The Commission has issued the enclosed Amendment No. 15 to Facility Operating License No. DPR-57 for the Edwin I. Hatch Nuclear Power Plant Unit No. 1. The amendment also includes Change No. 15 to the Technical Specifications in accordance with your application dated March 25, 1975.

GEORGIA POWER COMPANY
OGLETHORPE ELECTRIC MEMBERSHIP CORPORATION
EDWIN I. HATCH NUCLEAR PLANT UNIT 1
AMENDMENT TO FACILITY OPERATING LICENSE

ATTACHMENT TO LICENSE AMENDMENT NO. 15
CHANGE NO. 15 TO THE TECHNICAL SPECIFICATIONS
FACILITY OPERATING LICENSE NO. DPR-57
DOCKET NO. 50-321

SAFETY EVALUATION BY THE OFFICE OF NUCLEAR REACTOR REGULATION
SUPPORTING AMENDMENT NO. 15 TO FACILITY OPERATING LICENSE NO. DPR-57

FIGURE 3.6-2
 Minimum Temperature
 for Inservice Hydrostatic
 and Leak Tests

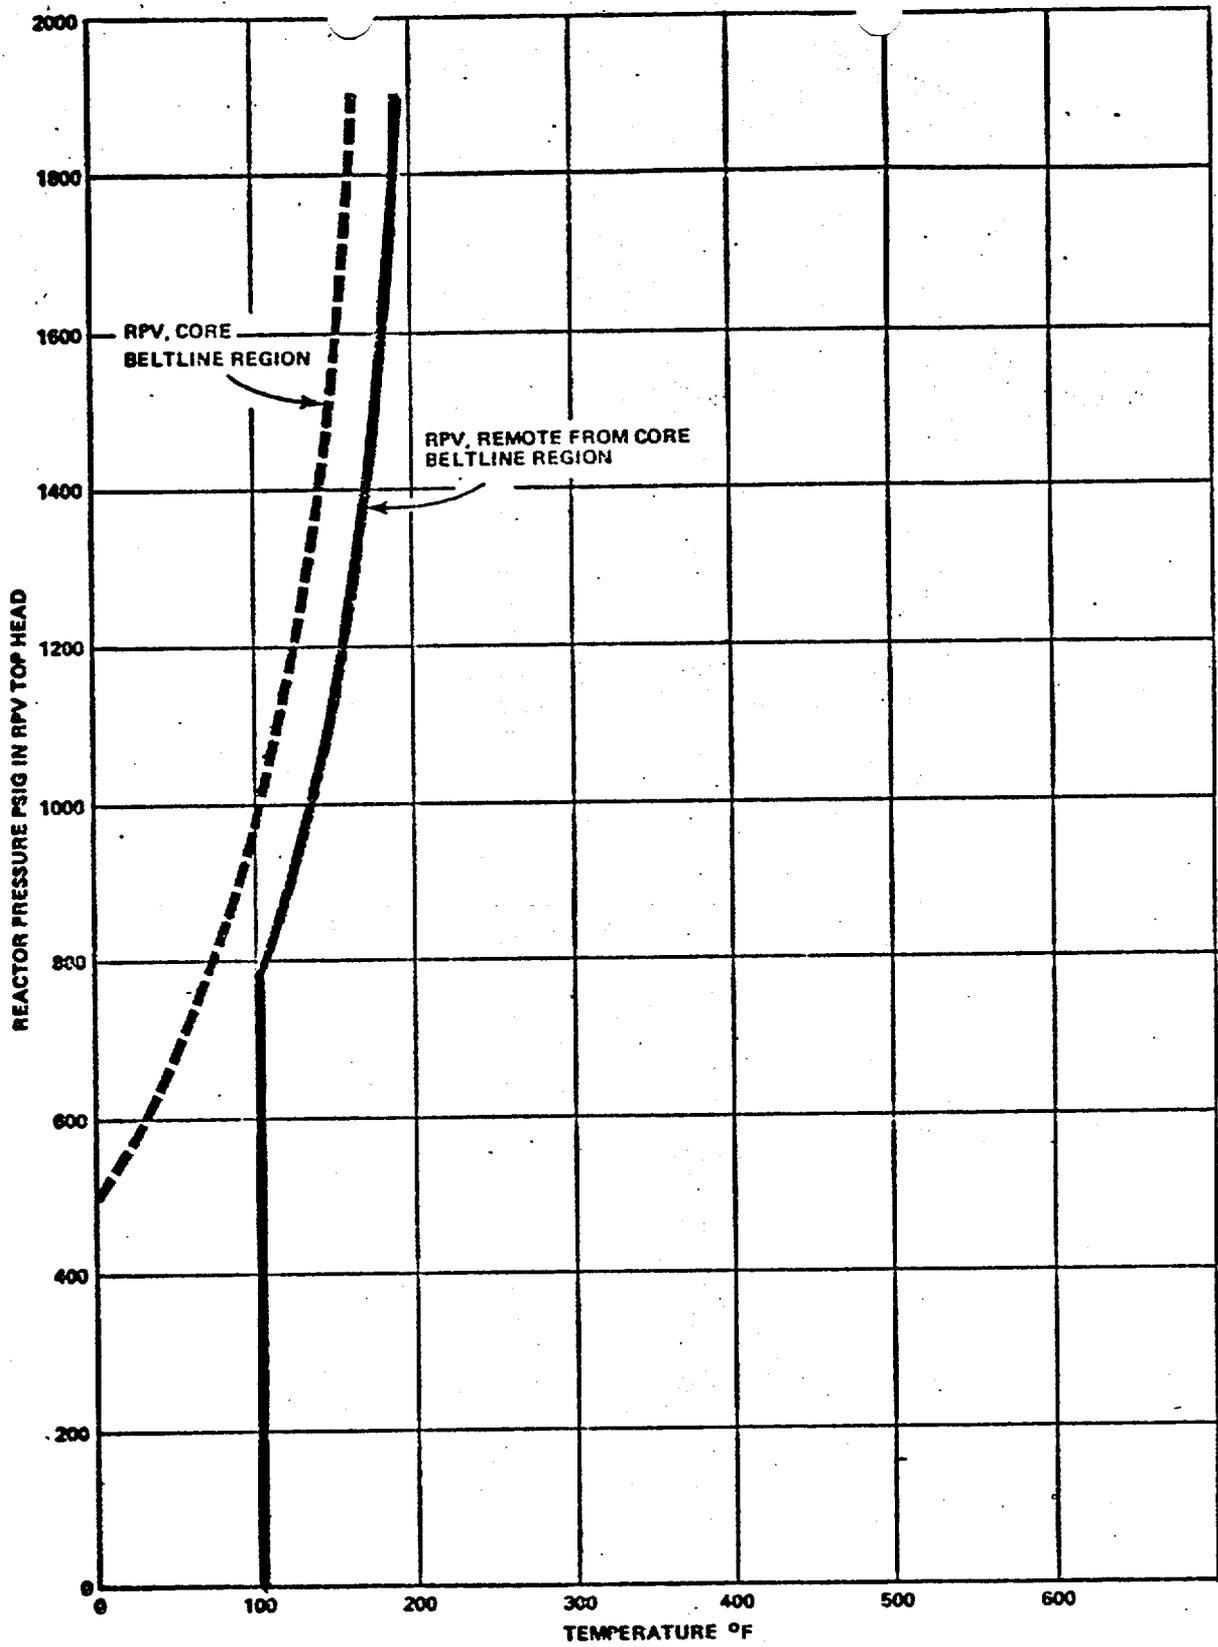
- a. Revise the surveillance requirements for temperature monitoring during reactor coolant heatup and cooldown.
- b. Incorporate the established minimum temperature requirement for leak testing and hydrostatic testing of the reactor pressure vessel into the appropriate graph (Figure 3.6-2).
- c. Incorporate a minimum temperature requirement for mechanical heatup or cooldown following nuclear shutdown into the appropriate graph (Figure 3.6-3).
- d. Revise the bases for the limiting conditions for operation and surveillance requirements associated with the Primary System Boundary in order to correct existing errors and to clarify the information presented.

The proposed change completes the pressure versus minimum temperature boundary curve for the reactor pressure vessel regions remote from the core beltline region during inservice hydrostatic and leak testing by establishing a 100°F minimum temperature over the pressure range from 0 psig to 800 psig. This change assures that the minimum temperature for inservice hydrostatic and leak testing is required to be greater than or equal to 100°F for all test pressures. A minimum temperature requirement of 100°F for inservice hydrostatic and leak testing is consistent with the requirements of the ASME Boiler and Pressure Vessel Code, Section XI.

Figure 3.6-2 establishes minimum temperature requirements for leak testing and hydrostatic testing required by the ASME Boiler and Pressure Vessel Code, Section XI.

FIGURE 3.6-3
MINIMUM TEMPERATURE FOR
MECHANICAL HEAT UP OR
COOL DOWN FOLLOWING
NUCLEAR SHUTDOWN

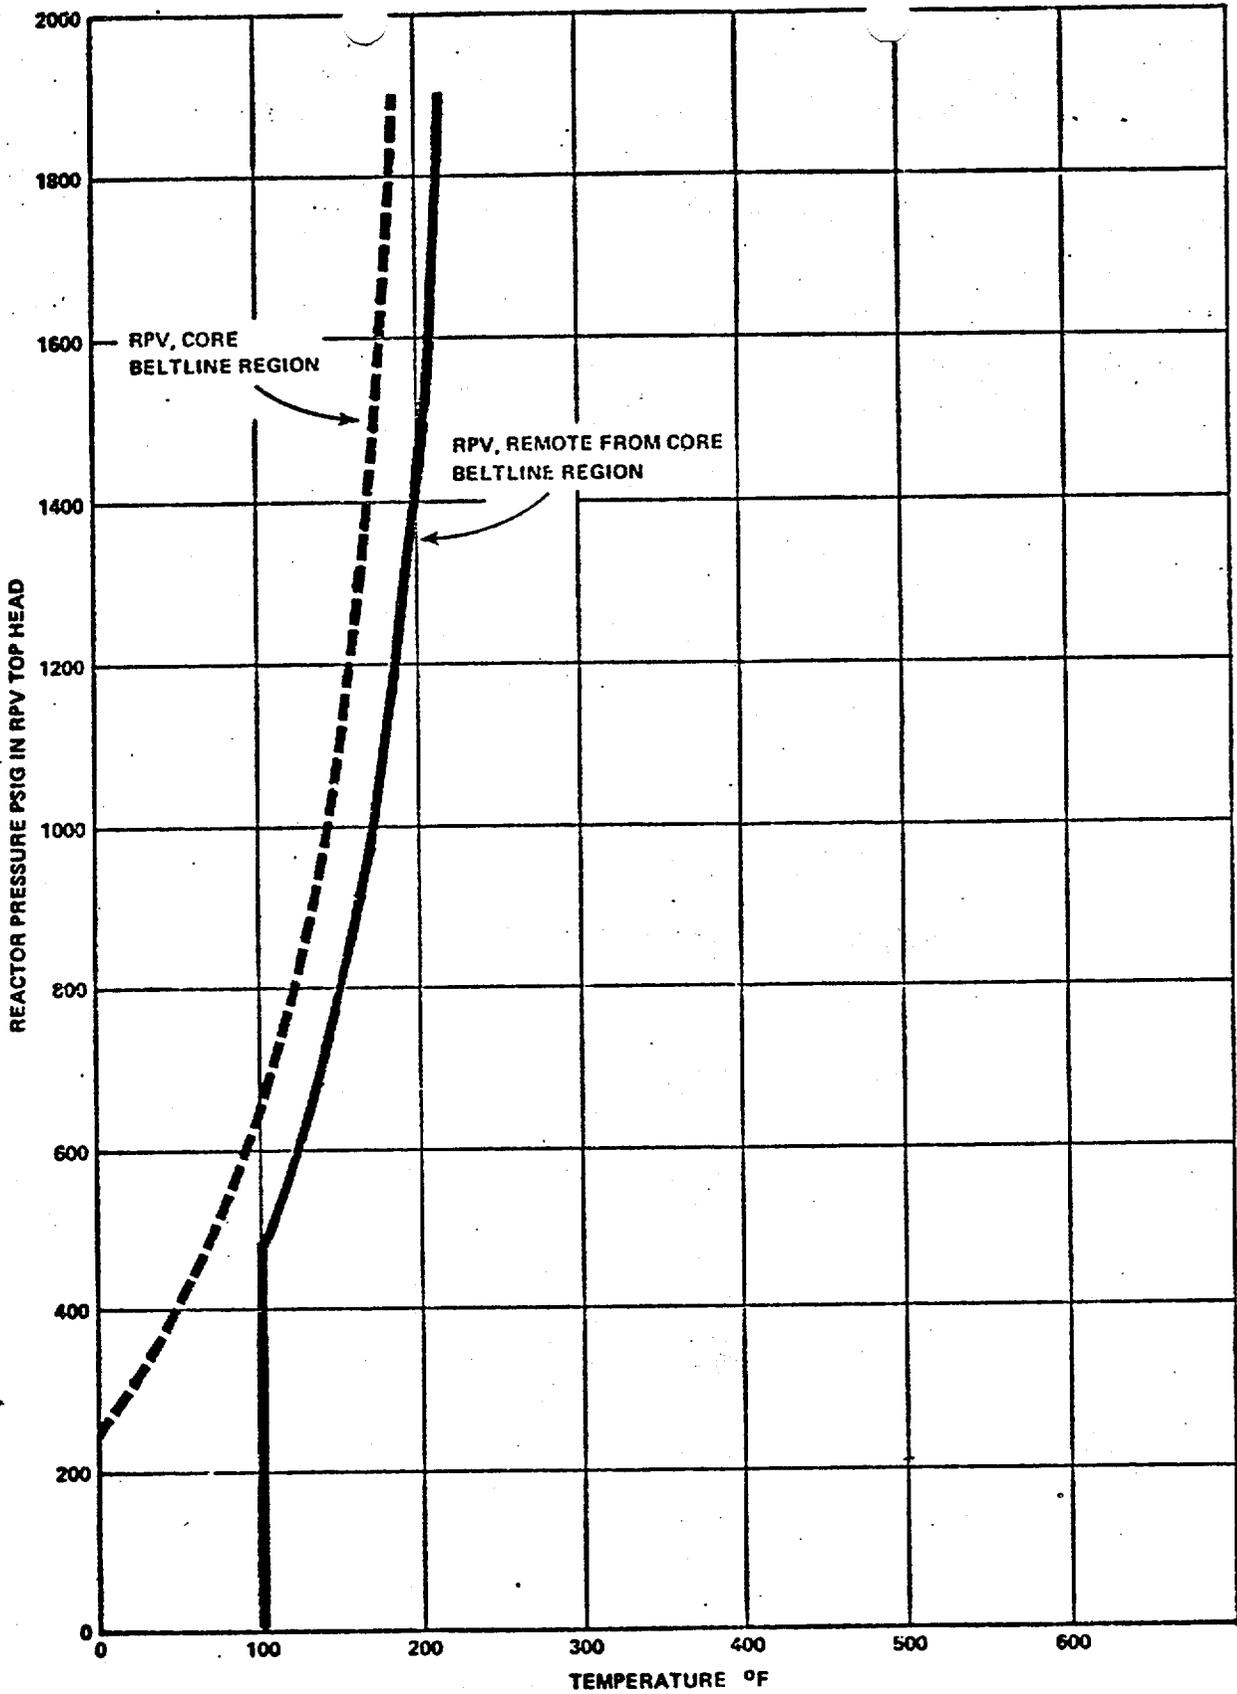
- C. Change associated with the minimum temperature requirement for mechanical heatup or cooldown following nuclear shutdown.

The proposed change completes the pressure versus minimum temperature boundary curve for the reactor pressure vessel regions remote from the core beltline during mechanical heatup and cooldown following nuclear shutdown by establishing a 100°F minimum temperature over the pressure range from 0 psig to 500 psig. Using the evaluation techniques presented in NRC Standard Review Plan, Section 5.3.2, "Pressure-Temperature Limits", it can be shown that mechanical heatup or cooldown following nuclear shutdown can be safely conducted at temperatures lower than 100°F if the pressure is appropriately reduced. Therefore, establishment of a minimum temperature requirement of 100°F is clearly conservative.

Figure 3.6-3 provides appropriate limitations for plant heatup and cooldown when the reactor is not critical. These curves assume heatup and cooldown rates up to 100 F per hour.
